Gardenia Wears Ltd.

ACCORD
on Fire and Building Safety in Bangladesh

Observations: Factory Building

Bolt missing and existence of gap in joints

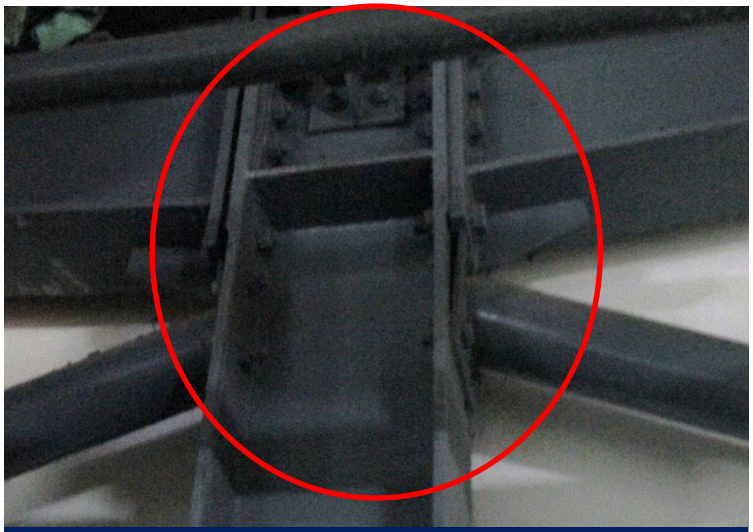
Missing bolts & gap between beam-column connection

Gap on bracing connection

Bolts were found missing in several locations. Factory engineer to check the connections and install missing bolts. Existence of gap was observed in beam-column and column-bracing connections at several locations. Factory engineer to identify the gaps and implement the appropriate remediation.

Corrosion in Steel member

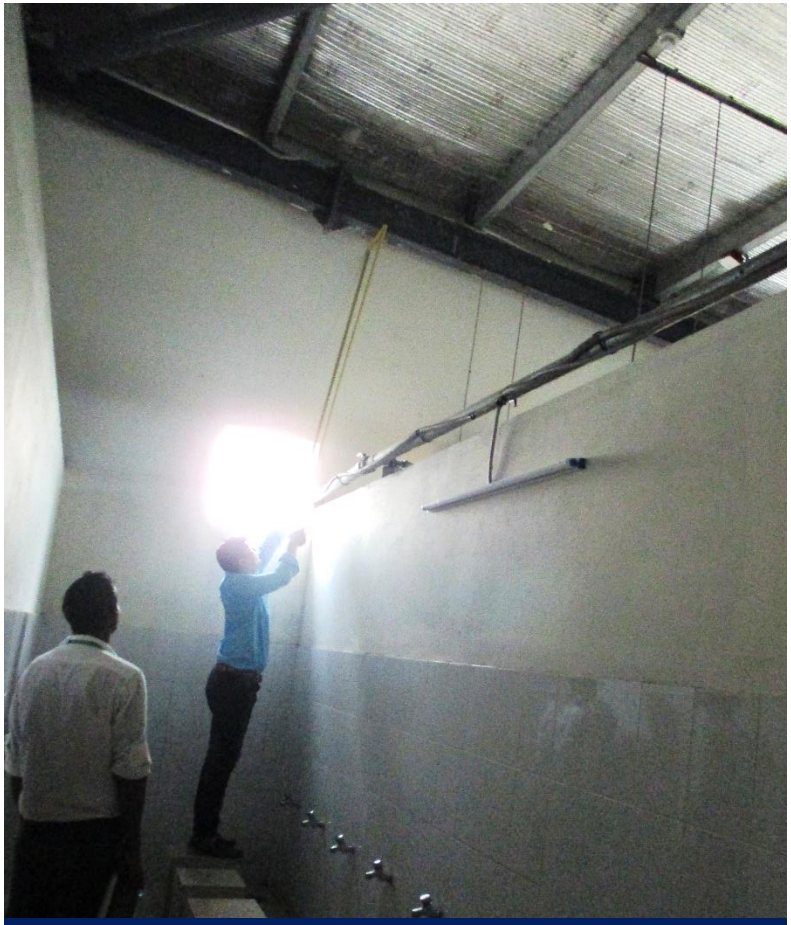
Corrosion was found on column base plate and sub-beam under toilet zone. Factory is required to find out all the deteriorated areas and apply suitable method to protect the steel members from corrosion.

Corrosion at column base plate

Corrosion at sub-beam under toilet zone

Mismatch in rafter size

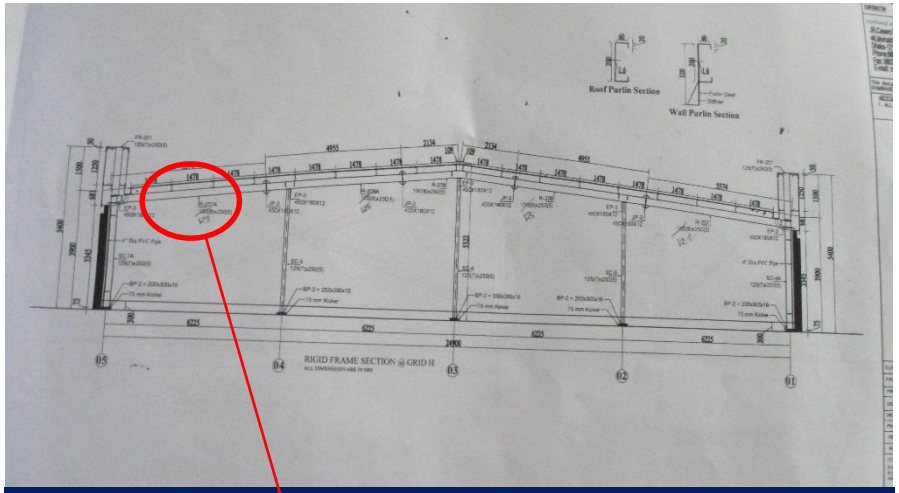
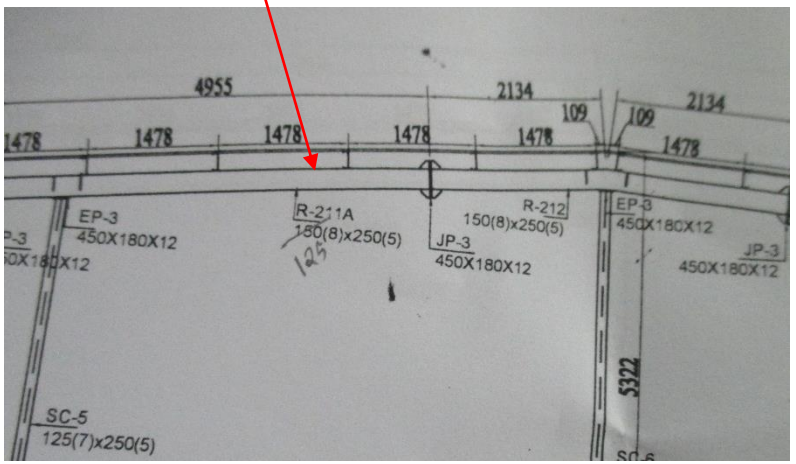
Size of rafter at end bay was found 125 mm x 250 mm instead of 150 mm x 250 mm. Factory engineer is required to update the drawing reflecting actual site condition.

Rafter measuring

Section of end grid

Missing bolt, gap between rafter-column joint, improper bracing connection and lack of connection details on drawings

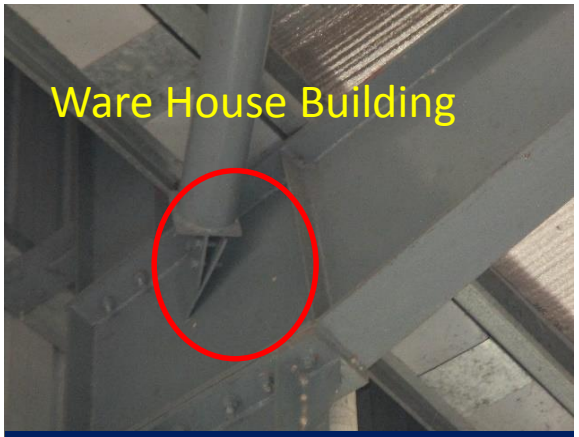
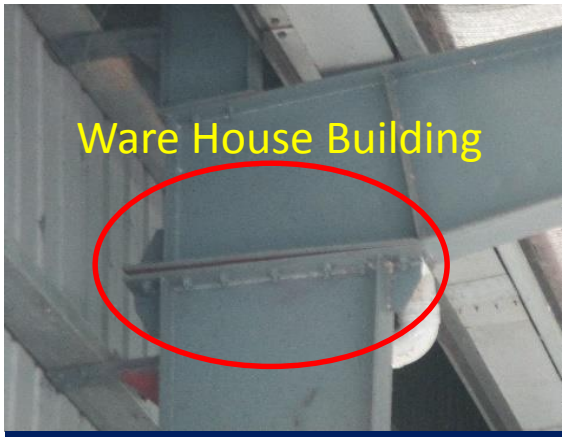
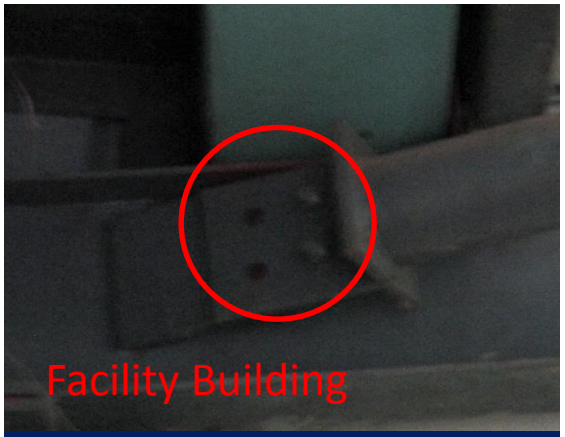
Bolts were found missing in several locations of both structures. Factory engineer to check the connections and install missing bolts. Significant gap was observed in beam-column and column-bracing connections. Factory engineer to identify the gap and implement the proper remediation. Moreover, improper bracing connections were found and connection details of bracings were not available on provided drawings.

Missing bolt

Improper connection

Gap at rafter-column joint
